# Access Compliance Report

## Public Rights-of-Way

Intersection ID: 12475	Main Street: AIRPORT_CENTER_PY	Cross Street: GOLF_ACRES_DR	Location: SE
ADA ID: D78CA5AE91ED	Ramp Type: PerpDiag	Initial Pass/Fail: Fail	Overall Compliance: No
			Severity Score: 33.75

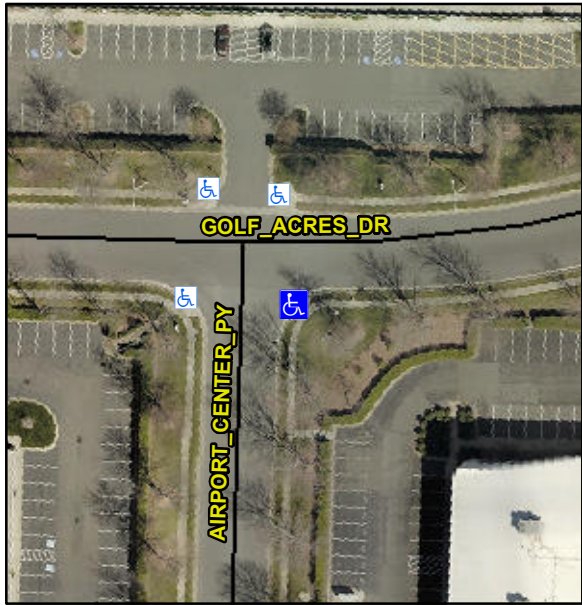
Codes/Mitigation Info/Possible Solution		Field Measurements/Component Compliance						
	Possible Solutions:							
	<b>Remove &amp; Replace Curb Ramp With Two New Directional Ramps or Equivalent.</b>							
	Surveyor Notes:							
	<b>N/A</b>							
	PROW/ADA:							
	<b>Not Found, R304.5.1, R304.5.3</b>							
Street 1 Name	<b>GOLF ACRES DR</b>							
Stop Condition-Street 2	<b>None</b>							
Street 2 Name	<b>AIRPORT CENTER PY</b>							
Stop Condition-Street 1	<b>StopSign</b>							
Total Cost:		\$	<b>3200.00</b>
